SAFETY RECALL NOTICE

2011-2015 Cannondale Mountain Bikes equipped with One Piece Integration (OPI) Stem

OPI Stem
(handlebar stem)

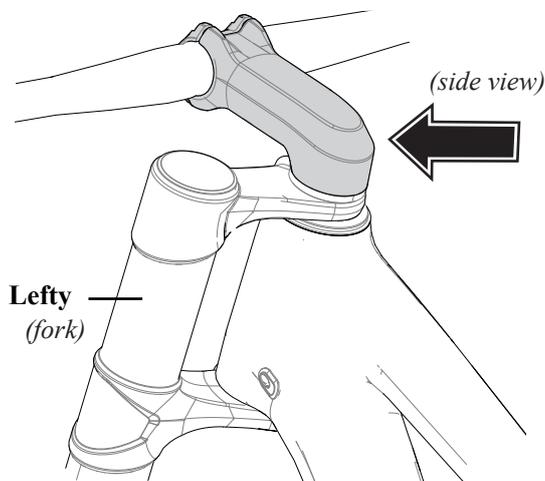
Recalled Product: This recall affects Cannondale mountain bikes produced between 2011-2015 with a Lefty front fork assembled with a component known as an “OPI Stem” and an “OPI Steerer.” The OPI Steerer is being recalled. It is located inside the headtube and is not visible. The Lefty fork and the OPI Stem ARE NOT being recalled.

- OPI Stems are marked with the “OPI” logo in black with a white stripe above. OPI Stems look smooth and are rounded at the bike head tube.
- OPI Stems have no stem bolts, only 4 handlebar bolts.

Hazard : OPI steerers affected by this recall have reduced fatigue life which could lead to breakage of the fork clamps or bolts over time. If that happened, a rider could lose control leading to an accident.

Remedy: Consumers with a bicycle equipped with an OPI stem should immediately stop using the bicycle and contact the nearest Authorized Cannondale Bicycle Dealer. Cannondale Dealers will inspect the bicycle OPI stem and fork for any damage that may have occurred and fit the OPI stem steerer system with a reinforcement part and install new Lefty clamp bolts.
